MONTGOMERY COUNTY PLANNING DEPARTMENT
THE MARYLAND-NATIONAL CAPITAL PARK AND PLANNING COMMISSION

MEMORANDUM

PROJECT NAME: Seven Locks Hills

CASE #: 120060370

PRELIMINARY SUBDIVISION PLAN
LOTS 26 AND 27

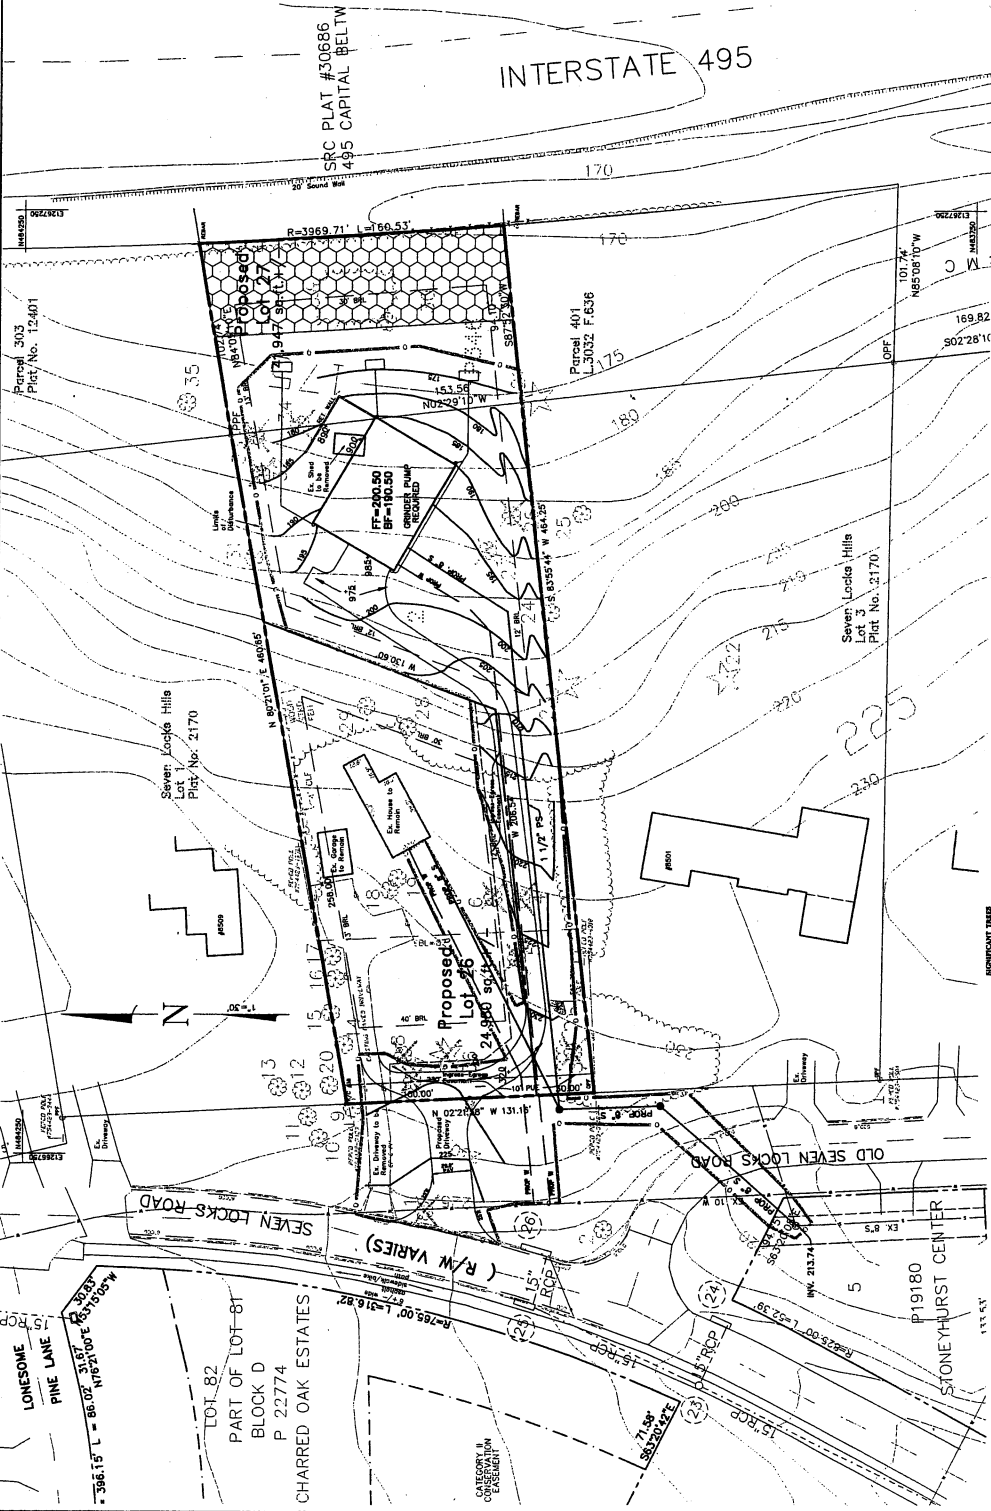
1. Show all existing planimetric and topographic details specifically storm drainage, driveways adjacent and opposite the site, sidewalks as well as existing rights of way and easements on the preliminary plan.

2. Necessary dedication for Seven Locks Road and Old Seven locks Road in accordance with the master plan.
3. Grant necessary slope and drainage easements. Slope easements are to be determined by study or set at the building restriction line.

4. We did not receive complete analyses of the capacity of the downstream public storm system(s) and the impact of the post-development runoff on the system(s). As a result, we are unable to offer comments on the need for possible improvements to the system(s) by this applicant. Prior to approval of the record plat by the Department of Permitting Services (DPS), the applicant's consultant will need to submit this study, with computations, for review and approval by DPS. Analyze the capacity of the existing downstream public storm drain system and the impact of the post-development ten (10) year storm runoff on same.

5. In accordance with Section 49-35(e) of the Montgomery County Code, sidewalks are required to serve the proposed subdivision.
6. The sight distances study has been accepted. A copy of the accepted Sight Distances Evaluation certification form is enclosed for your information and reference.

7. Record plat to reflect a reciprocal ingress, egress, and public utilities easement to serve the lots accessed by each common driveway.
8. Record plat to reflect denial of access along Old Seven Locks Road.
